CLIENT:
The Parish of Our Lady of Mount Carmel
Blackley
PROJECT:
Our Lady of Mount Carmel, Blackley

Work Areas / Repair Issues / Site Setup

PURPOSE OF ISSUE:			
Construction			
DRAWN BY:	CHECKED:	DATE:	SCALE @ A1:
JW	AP	09.06.23	As indicated
JOB NO:	STATUS CODE:	DRAWING NO:	REV
4200	A	102	A
FILE IDENTIFIER:			
MC-BTP-00-ZZ-DR-A-4200_102.A			
Elizabeth House 486 Didsbury Road Heaton Mersey Stockport SK4 3BS 0161 443 1221 info@bernardtaylor.co.uk www.btarchitects.co.uk

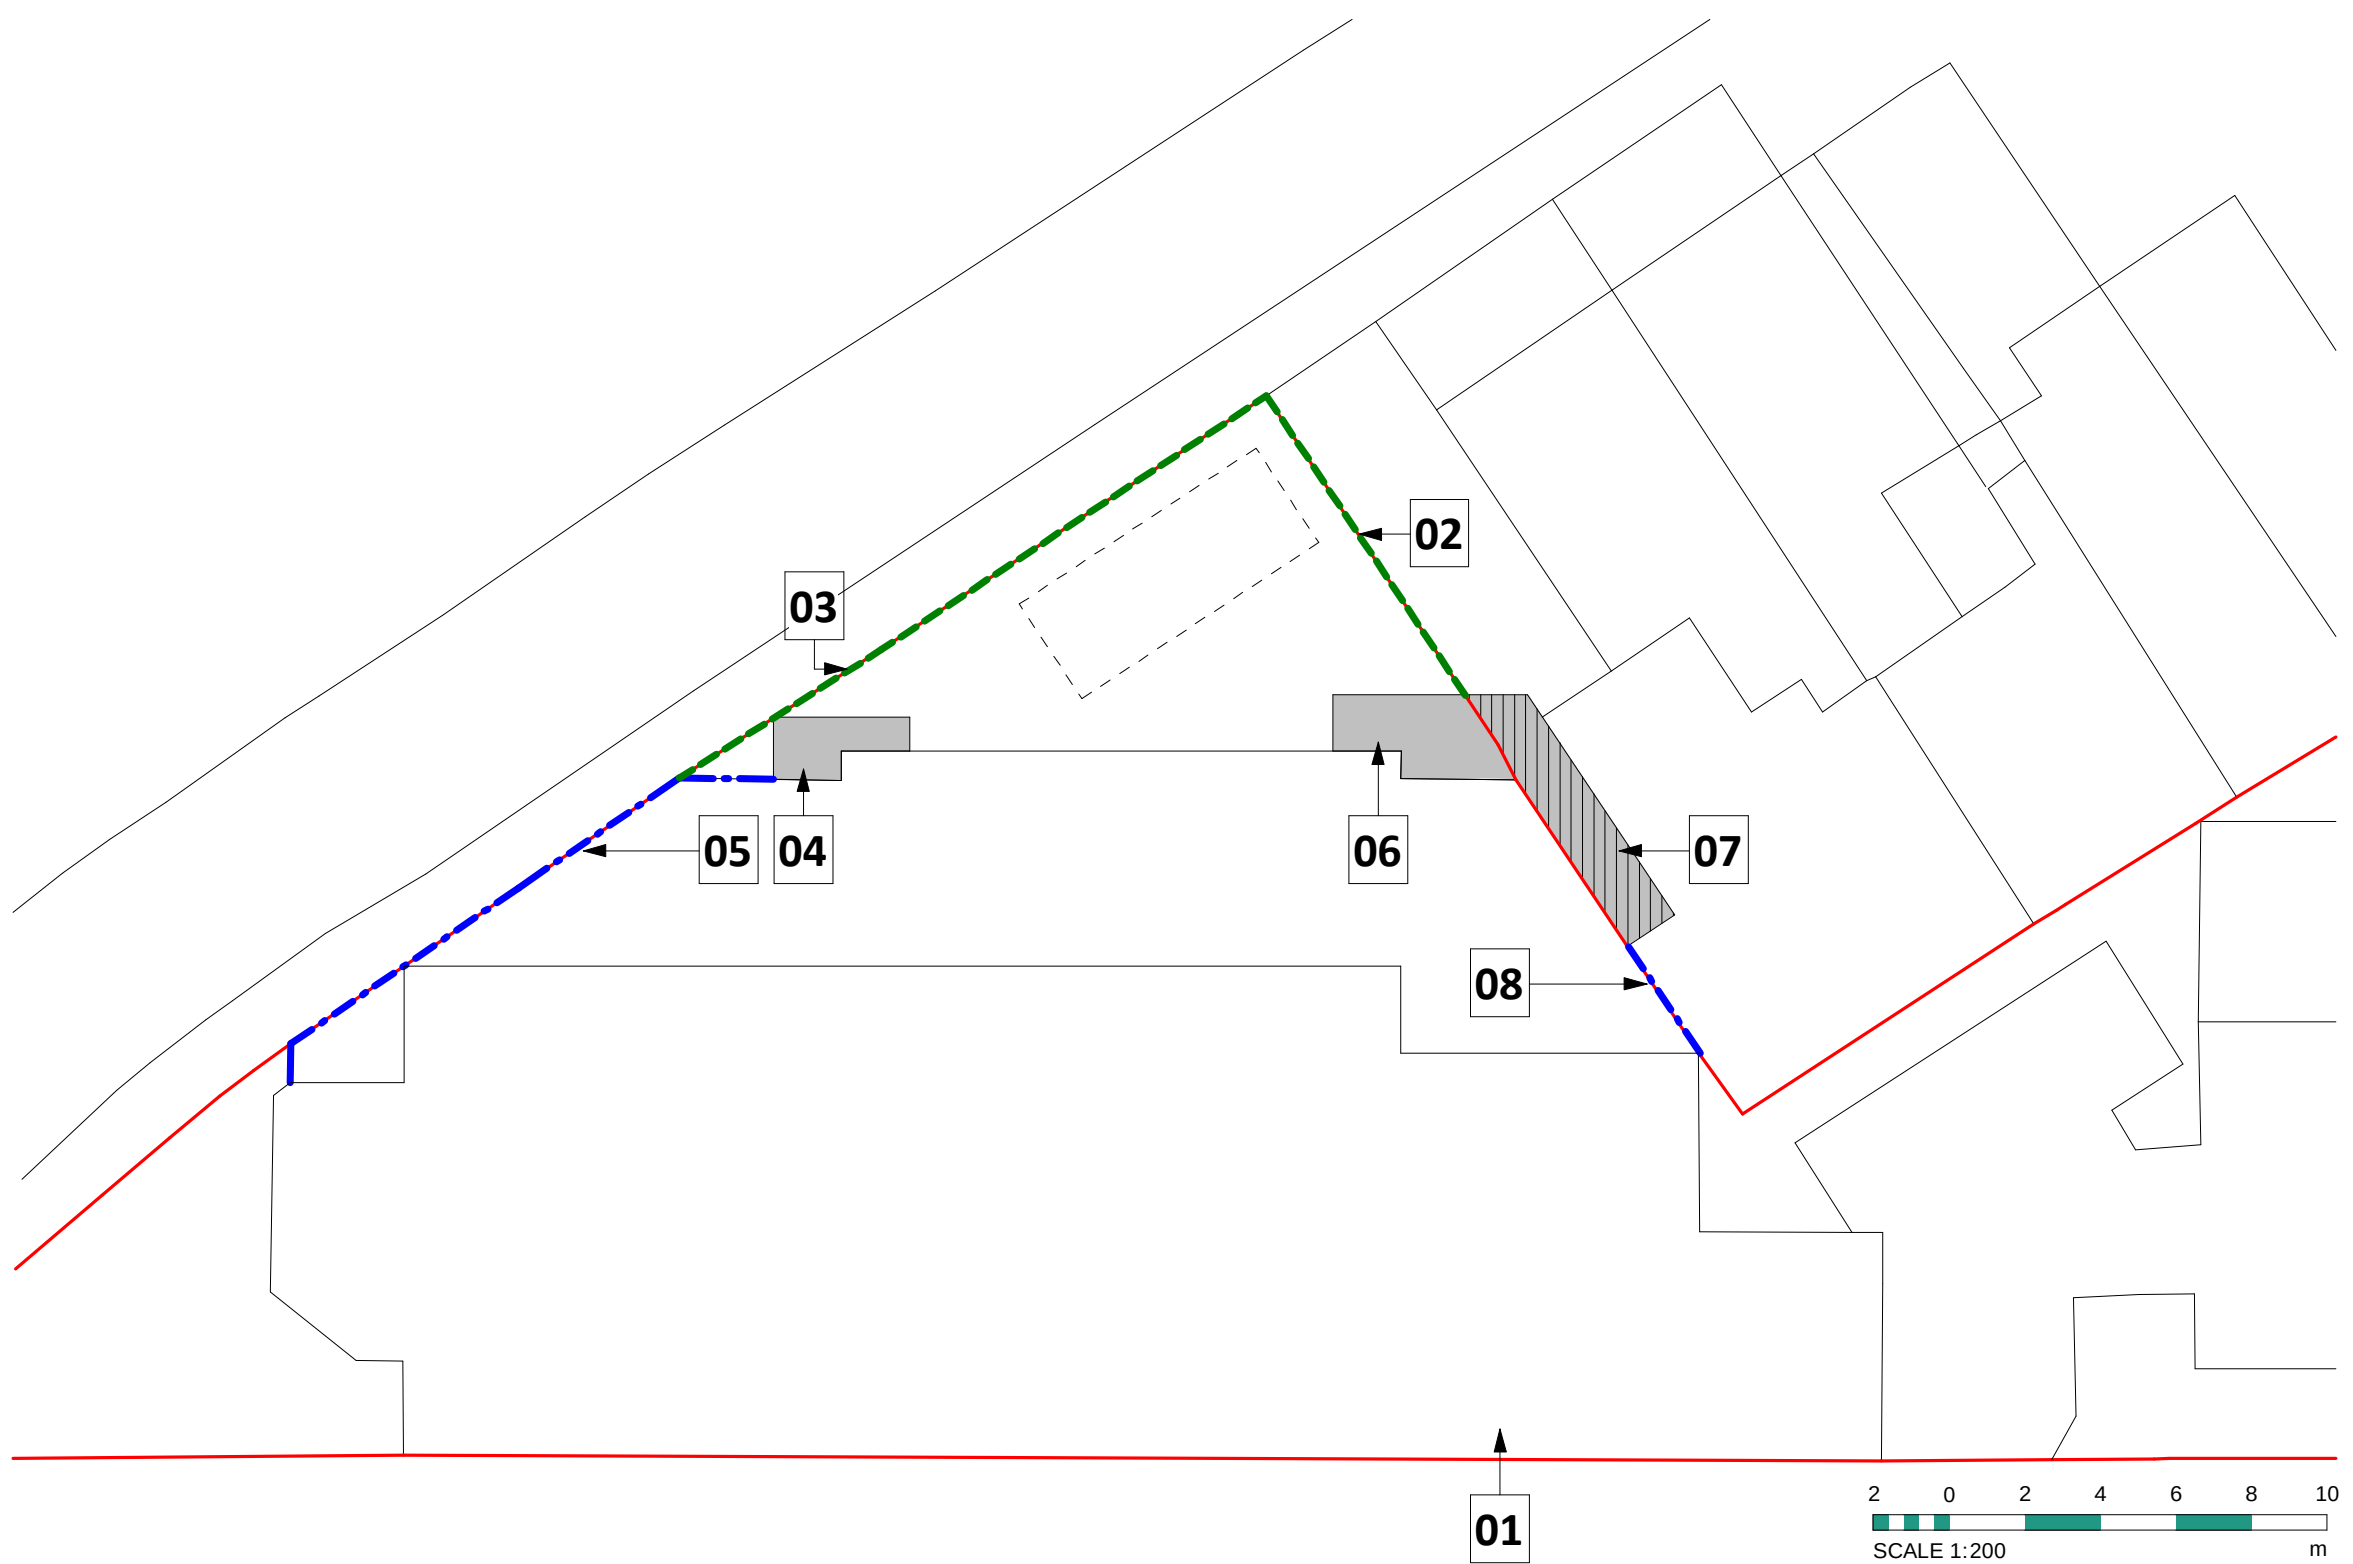
- 01** ~~Max 7.5m x 3m combined site office / welfare / toilet cabin located in garden in location to minimise damage to existing planting –~~
Welfare facilities will be located in the presbytery (REV A)

~~5. Refixing the existing coping stones~~
~~The existing terracotta coping stones are to be removed and re-fixed over new damp proof course.~~

5. Existing coping stones (REV A)

Existing copings to remain in place.

~~**8-North Aisle (South)-pitched roof**~~
~~Due to poor condition, remove and refix slates of south of pitched roof re-using existing slates where possible, and otherwise sourcing reclaimed tiles to match existing. Slates are to be re-fixed starting at approx. 450mm offset from the valley gutter. This will create a walkway for access each end of the roof for maintenance / inspection purposes.~~

8. North Aisle (South) pitched roof (REV A)

Carefully remove and refix 3-courses of slates to the south of pitched roof *only*, re-using existing slates where possible, and otherwise sourcing reclaimed tiles to match existing to allow for removal of temporary Ubbink Ubiflex and fixing of new TCSS flashing. Make allowance for 450mm offset from the valley gutter. This will create a walkway for access each end of the roof for maintenance / inspection purposes.

~~10. Existing Cast Iron Box Gutter~~

10. Existing Cast Iron Box Gutter (REV A)

The existing cast iron box gutter is to be retained. New TCSS flashing (as addressed in point 8) is to be dressed min. 75mm into the existing box gutter.

A	18.09.23	JW	Purpose of issue updated to construction and notes updated to reflect updated scope of work following tender
Rev	Date	Int	Description
